Liverpool Hospital Multi-storey Carpark Modification 1

Façade Artwork, Solar and Design Changes
State Significant Development Modification Assessment
(SSD-10388-Mod-1)

December 2021

Published by the NSW Department of Planning, Industry and Environment

Figure 4 | Proposed façade amendments, north (top) and east (bottom) elevations (Source: Applicant's Modification Report 2021)

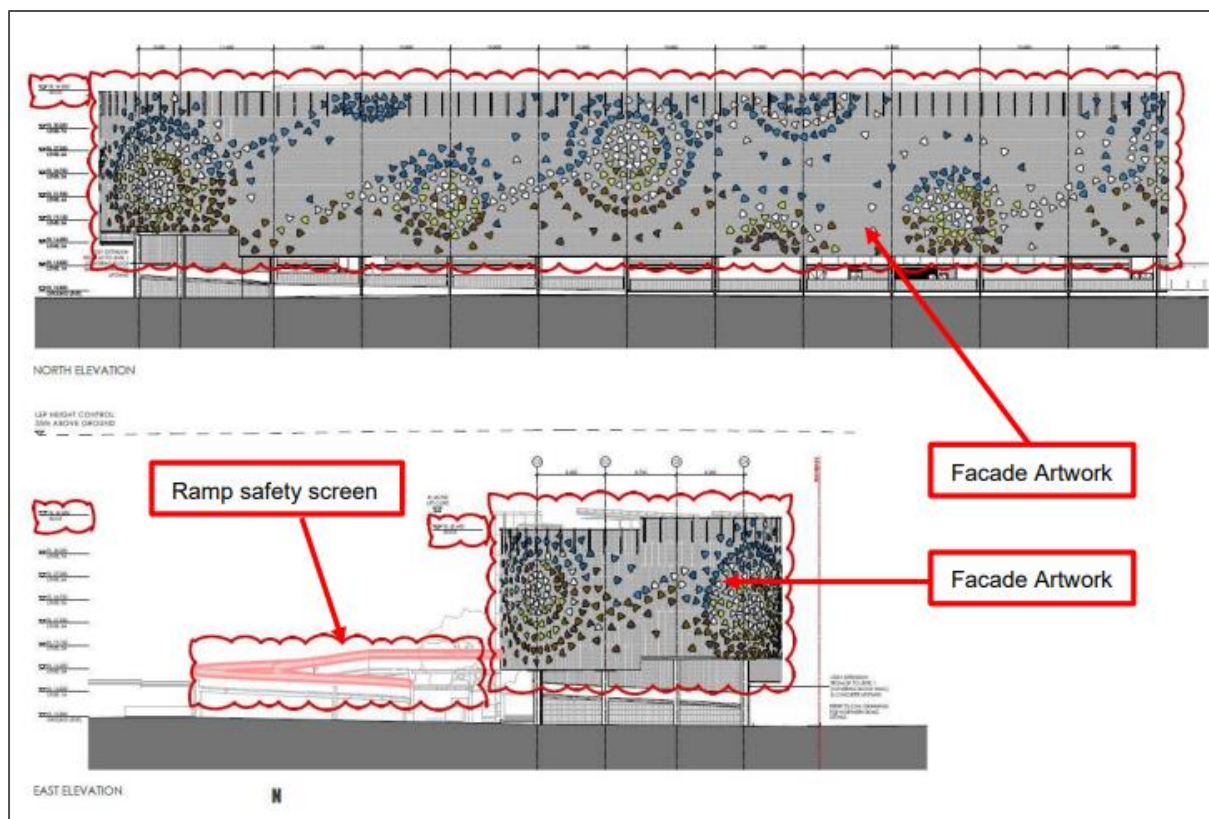
- replacement of the approved façade with a new façade that incorporates artwork by Aboriginal artist Bibi Bara, in accordance with condition of consent D26 (public art) of SSD-10388.
- introduction of a new 2.2m safety screen along the length of the entry and exit ramp, to provide additional safety measures.
- increase in the height of the approved roof top parapet safety screen by 500mm, to provide additional safety measures.

The proposed artwork, designed by indigenous artist Bibi Bara, represents the Flower of Gandangarra through a series of coloured aluminium panels fixed to the stainless-steel tensile mesh that encloses the carpark (**Figures 8 and 9**). The amended design would replace the entirety of the originally approved façade. The overall materiality of the carpark structure, incorporating stainless-steel metal and wire mesh and concrete, would remain unchanged.

The Multi-storey Carpark is prominent in sightlines from the east and north. The Department is satisfied that the proposed façade artwork would generate visual interest and improve the overall appearance of the structure, particularly in views from the railway line and Liverpool Boys and Liverpool Girls High Schools from the north. The Department notes that the artwork was created by an indigenous artist and is designed to reinforce connection to Country. Overall, the inclusion of the

artwork is considered to address the comments made by the SDRP and would meet the requirements of condition D26.

Figure 5 | Proposed north-south section (Source: Applicant's Modification Report 2021)

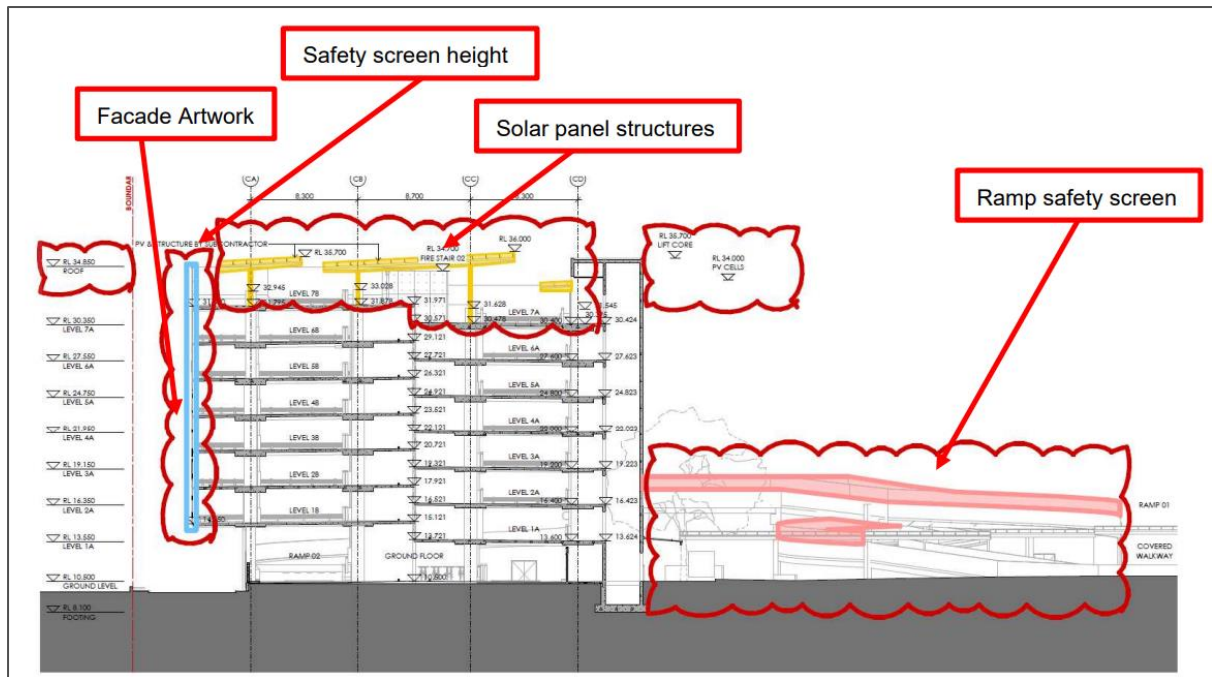
- installation of new solar PV array and associated support structures at roof level, to provide sustainability improvements (**Figures 5** and **6**). The array would incorporate approximately 1032 solar panels, connected to an inverter station comprising four 100kW SMA Core 2 Inverters and a secondary control panel.

The modification application also proposes the introduction of solar panels and associated support structures to the carpark rooftop. The top of the solar panels would reach RL36, an increase beyond the previously approved maximum RL35.7. However, the overall height of the carpark (26.25m) would

continue to comply with the maximum height limit provision of 35m under the Liverpool Local Environmental Plan 2008.

The Department is satisfied that the inclusion of the proposed solar panels would not add unacceptable bulk to the Multi-storey Carpark and would therefore not harm the overall appearance of the structure.

Figure 7 | Proposed internal reconfiguration, ground floor level (Source: Applicant's Modification Report 2021)

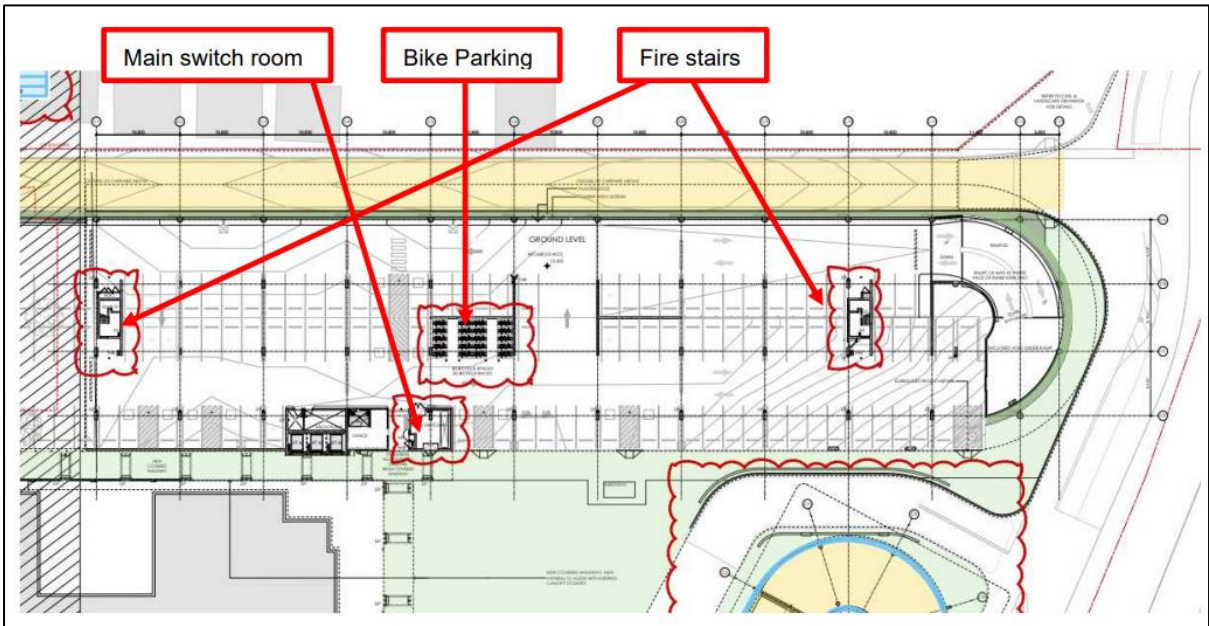
- reduction of four car parking spaces to accommodate the solar panels and the additional accessible car parking spaces.
- reconfiguration of the eastern stairwell at all levels (**Figure 7**).

- relocation of the:
 - western fire stair on all levels (previously adjacent to lift core).
 - ground floor level bicycle parking.
 - ground floor level main switch room adjacent to the lift core (**Figure 7**).
